Re: Final Plat – Vrable Healthcare (Case 13-002FDP/FP)

13-002 FDP/FP
 Final Development Plan/Final Plat
 Vrable Skilled Nursing Care
 Tuller Road and Tuller Ridge Road

Agenda Item	3
Case Number	13-002FDP/FP
Proposal	A new 131,455-square-foot skilled nursing facility with associated site improvements on 6.34 acres on the south side of Tuller Road between Tuller Ridge Drive and Riverside Drive.
Request	Review and approval of a <u>final development plan</u> under the Planned District provisions of Zoning Code Section 153.050. Review and approval of a <u>final plat</u> under the provisions of Sections 152.015 – 152.022 of the Subdivision Regulations.
Site Location	4500 John Shields Parkway Southwest corner of Tuller Road and Tuller Ridge Drive.
Owner/Applicant Representative	Tuller Henderson LLC; Owner and Allan Vrable; Applicant Ben Hale, Smith and Hale, Attorney.
Case Manager	Jennifer M. Rauch, AICP, Planner II. (614) 410-4690 jrauch@dublin.oh.us
Planning Recommendation	Based on Planning's analysis, the proposal complies with the applicable review criteria and the anticipated development standards and approval is recommended. 1) Approval of the <u>final development plan</u> with fi

Proposed Landscape Plan

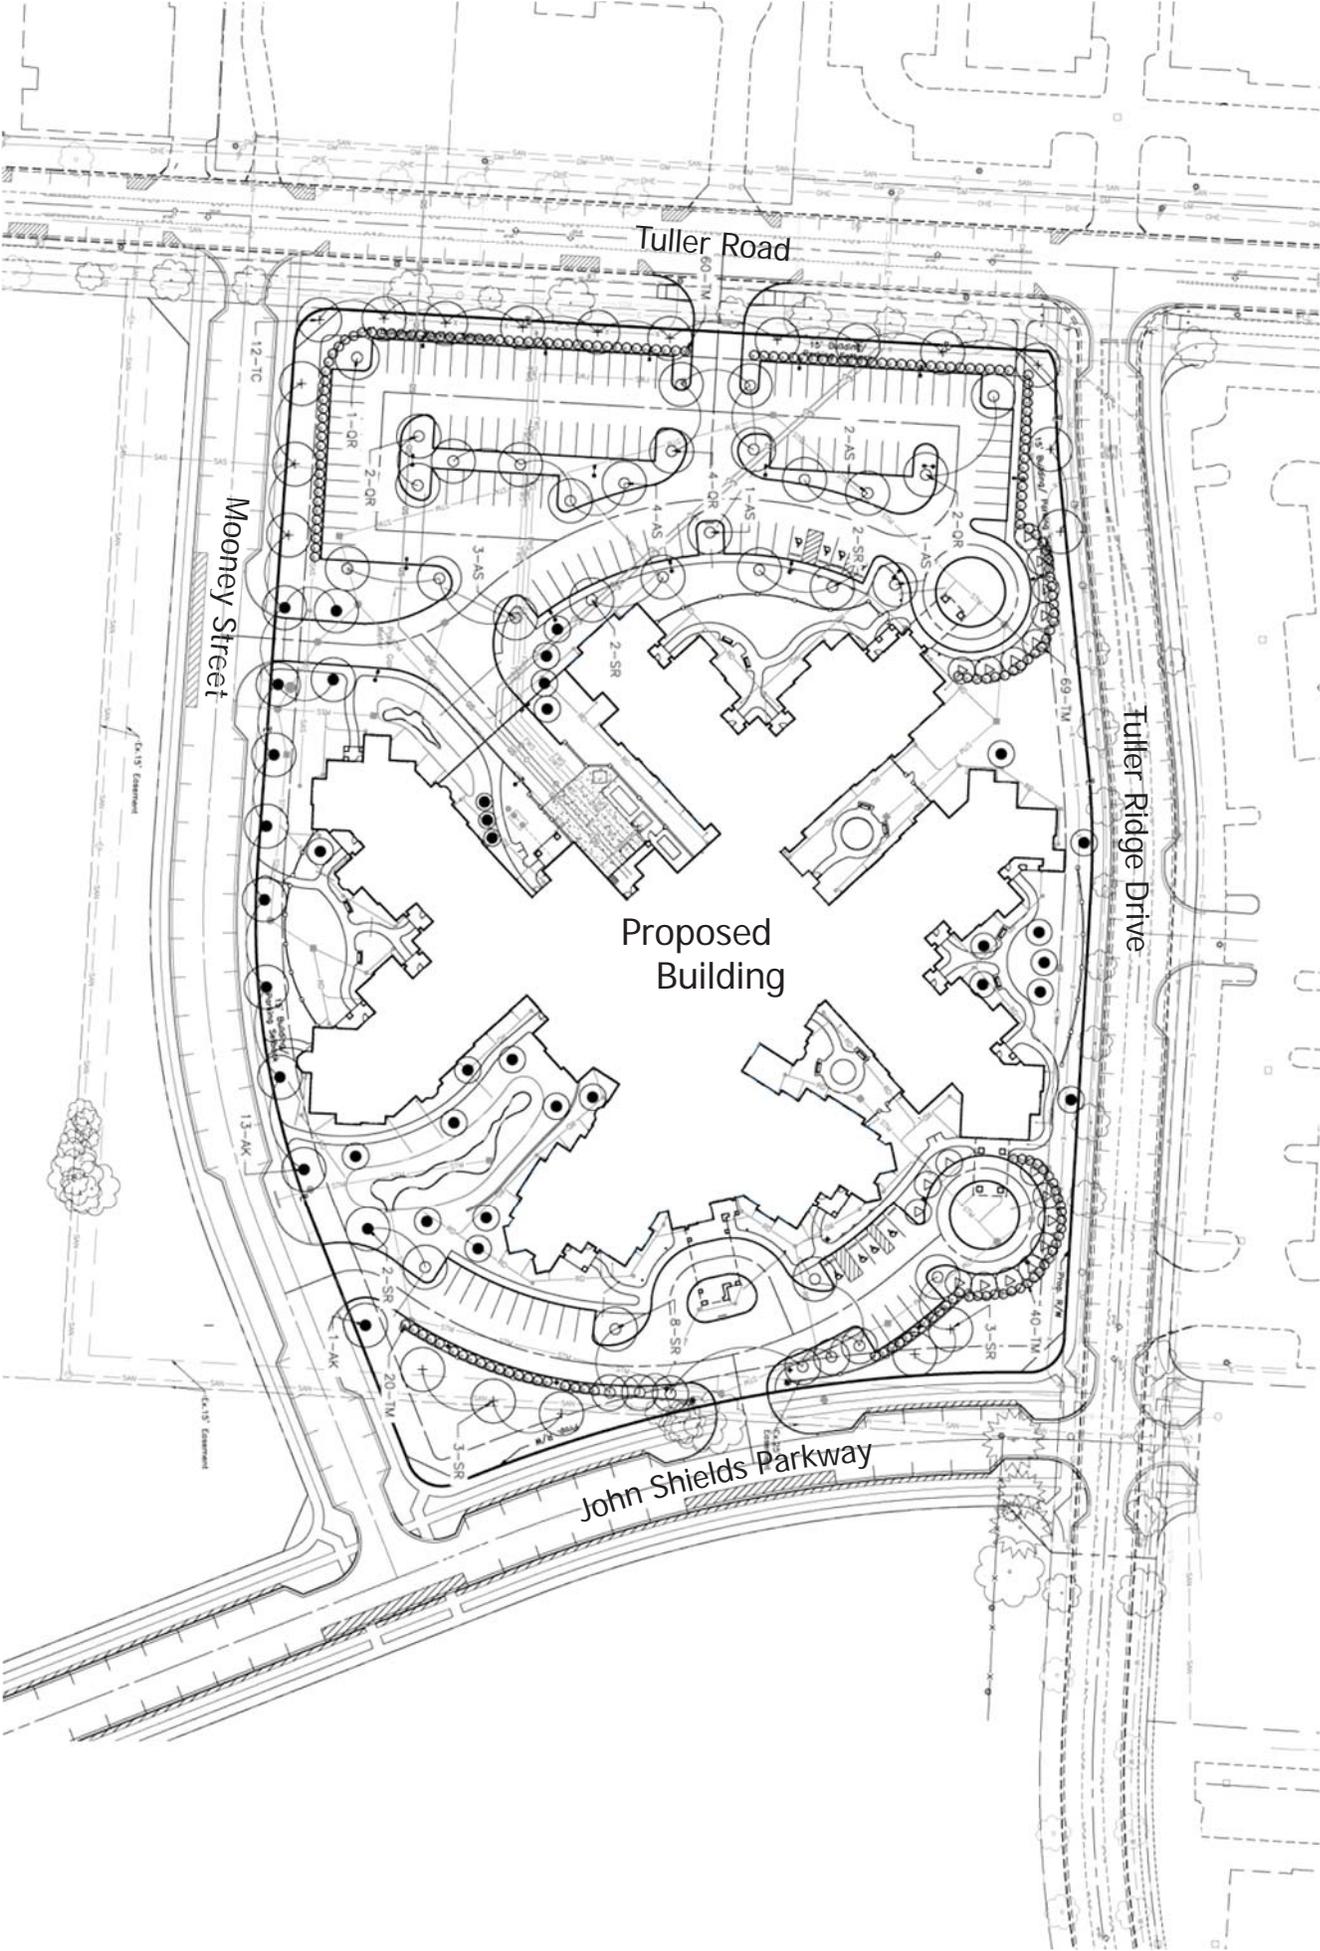
Removal of 241 caliper inches of trees is required for the development of the site, with 111 caliper inches replaced on site. The deficiencies are to be recovered through replacement fees. However, Planning has identified several areas where additional replacements could be located on site to supplement the required landscape and recommends the applicant revise the plans accordingly. Additional inches will be removed as part of the public infrastructure improvements. Should the City be responsible for the public infrastructure and roadway improvements then the applicant will not be responsible for this additional tree replacement.

Ornamental trees are used to meet the tree replacement, which is not permitted per Code. Planning recommends the applicant substitute the use of ornamental trees for larger trees to meet Code.

Proposed Ground Signs

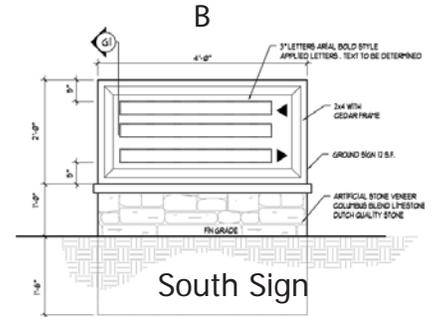
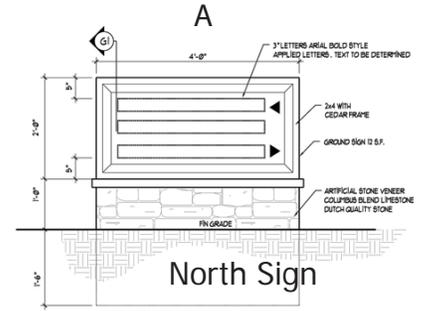
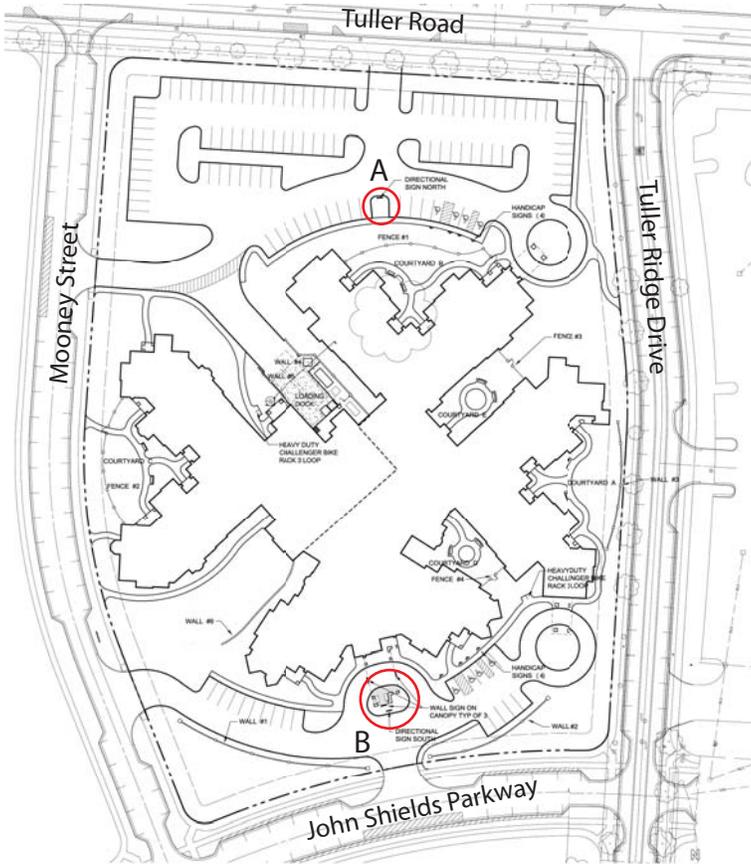
<p>6) <i>Signs</i></p> <p><i>Condition 5</i></p>	<p>Criterion met with Condition: The proposed ground signs meet the text for area and height. Planning will work with the applicant to finalize the sign colors for ground signs that complement the proposed building. The addition of the proposed wall sign is appropriate and helps to identify the main building entrance.</p>

Proposed Final Plat

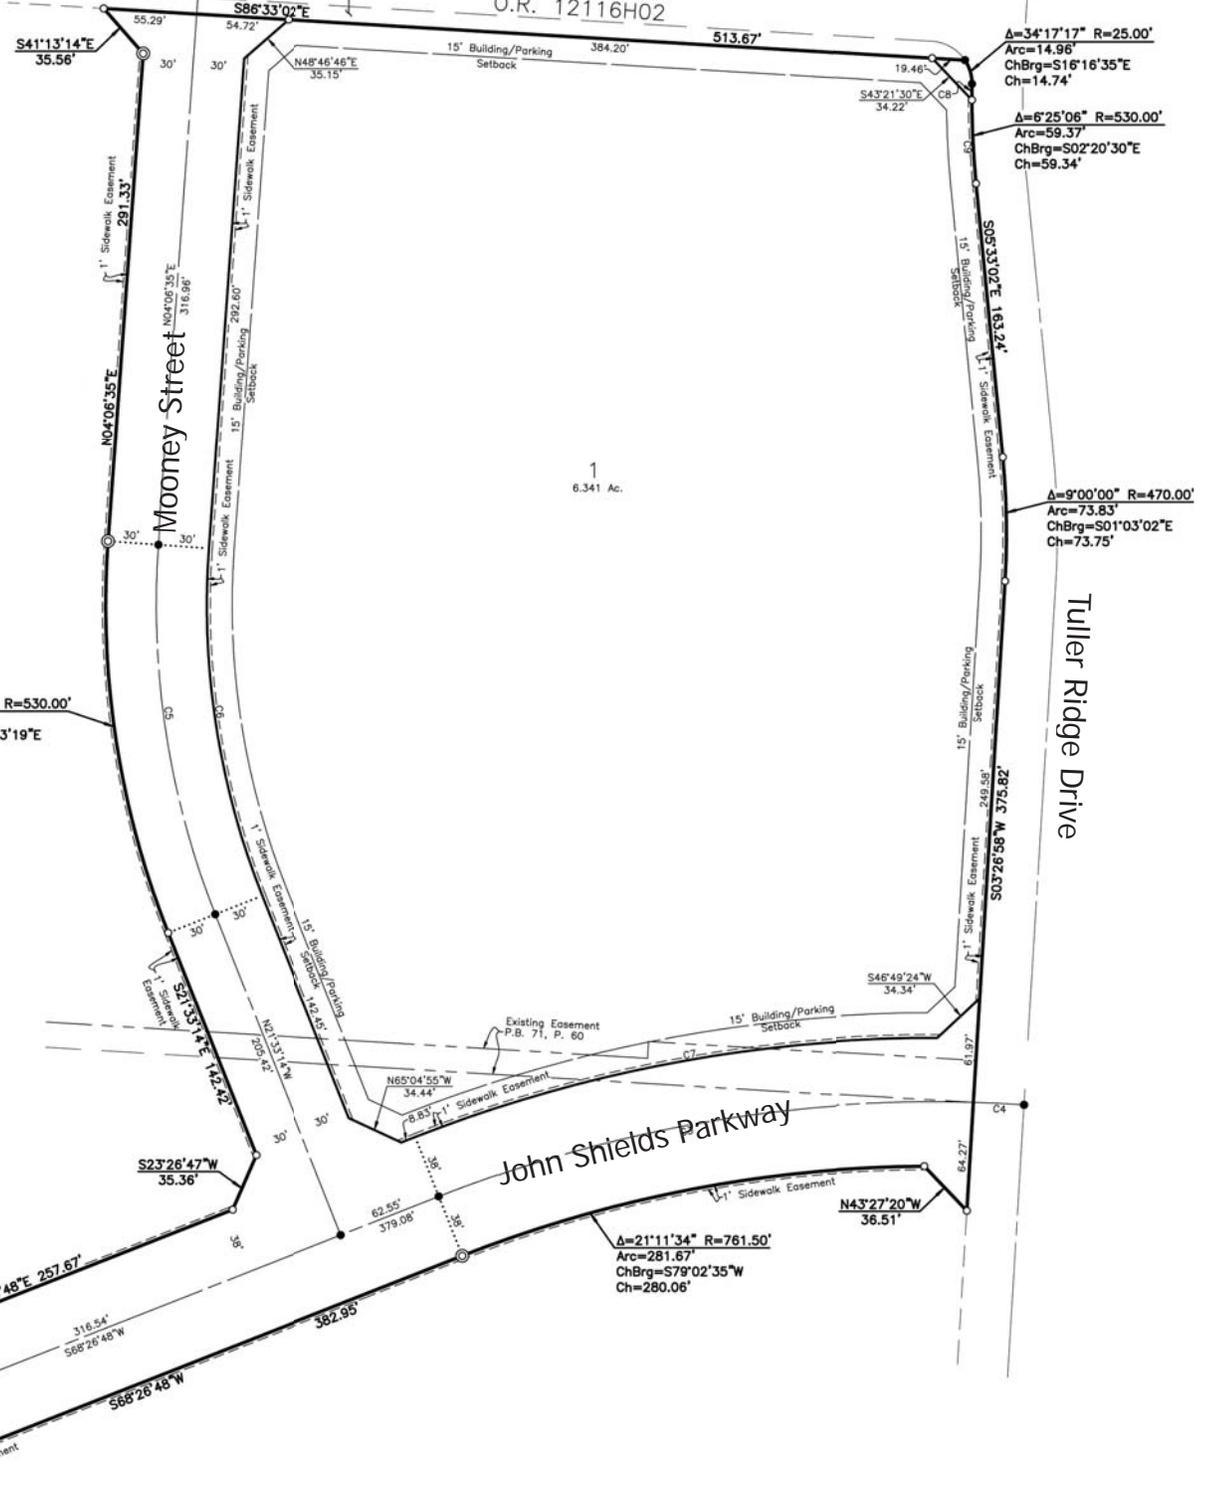
Details		Final Plat
Plat Notes	The proposed plat indicates the building and pavement setbacks, which are typically not included on a final plat. Engineering has also identified minor technical modifications be made to the proposed plat notes. Planning and Engineering recommend these minor technical amendments be made prior to the final plat submission to City Council.

Recommendation	
Approval	This proposal complies with the final plat review criteria and approval of this request is recommended with 1 condition.
Condition	1) The plat be revised to eliminate the setback requirements and incorporate the minor technical amendments identified by Engineering, prior to the final plat submission to City Council.
